Access Compliance Report

Public Rights-of-Way

(Curb Ramps)

Intersection ID: 22554	Main Street: OXWYNN LN	Cross Street: SUMMERTREE LN	Location: S
ADA ID: D4C2EF743C22	Ramp Type: PerpDiag	Initial Pass/Fail: Fail	Overall Compliance: No
Severity Score: 42.5			
Codes/Mitigation Info/Possible Solution		Field Measurements/Component Compliance

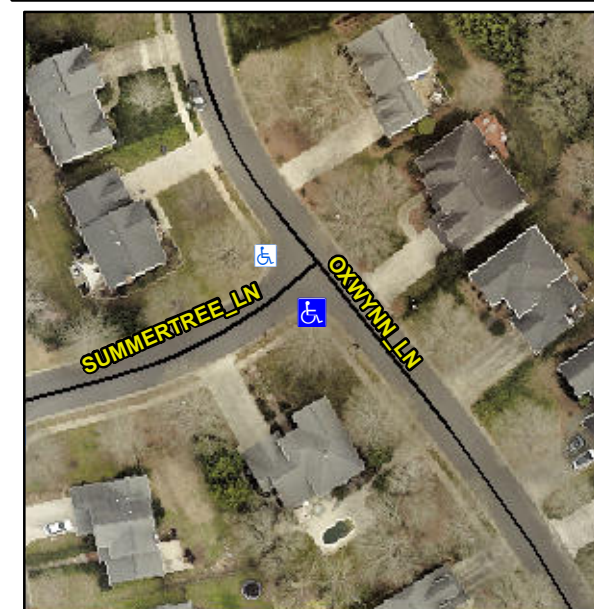
Compliance	Description	Data	Compliance	Description	Data
N/A	Ramp Length (in)	82.0	No	Ramp Slope (%)	9.3
No	Ramp Width (in)	34.0	No	Ramp XSlope (%)	5.6
N/A	Flare Type LT	N/A	N/A	Flare Type RT	N/A
N/A	Flare Slope LT (%)	N/A	N/A	Flare Slope RT (%)	N/A
N/A	Flare Traversable LT?	N/A	N/A	Flare Traversable RT?	N/A
N/A	Landing Length (in)	N/A	N/A	DWS Provided?	N/A
N/A	Landing Width (in)	N/A	N/A	DWS Contrast?	N/A
N/A	Landing Slope (%)	N/A	N/A	DWS Length (in)	N/A
N/A	Landing X Slope (%)	N/A	N/A	DWS Full Width?	N/A
N/A	Landing Curb? (Y/N)	N/A	N/A	DWS Offset (in)	N/A
N/A	Shared Landing?	N/A			
N/A	Gutter Ponding?	N/A	N/A	Gutter Slope (%)	N/A
N/A	Gutter Lip Ht (in)	N/A	N/A	Gutter X Slope (%)	N/A
N/A	Painted X Walk1?	No	N/A	Painted X Walk2?	No
	X Walk 1 Direction	To W		X Walk 2 Direction	To N
N/A	X Walk 1 Width (in)	N/A	N/A	X Walk 2 Width (in)	N/A
	X Walk 1 Slope (%)	0.3		X Walk 2 Slope (%)	3.0
	X Walk 1 X Slope (%)	4.8		X Walk 2 X Slope (%)	0.4

N/A	Ramp inside XWalk1?	N/A	N/A	Ramp inside XWalk2?	N/A
	Road Slope (%)	3.7	N/A	Clear Space?	N/A
	Road X Slope (%)	0.8	N/A	Clear Space to XWalk (in)	N/A
N/A	Any Obstructions?	N/A	N/A	Storm Grate/Utility Hazard?	N/A
	Obstruction Type			Storm Grate/Utility Type	
		N/A			N/A
			Yes	Surface Condition? (G/P)	Good

Remove & Replace Curb Ramp With Two New Directional Ramps or Equivalent.
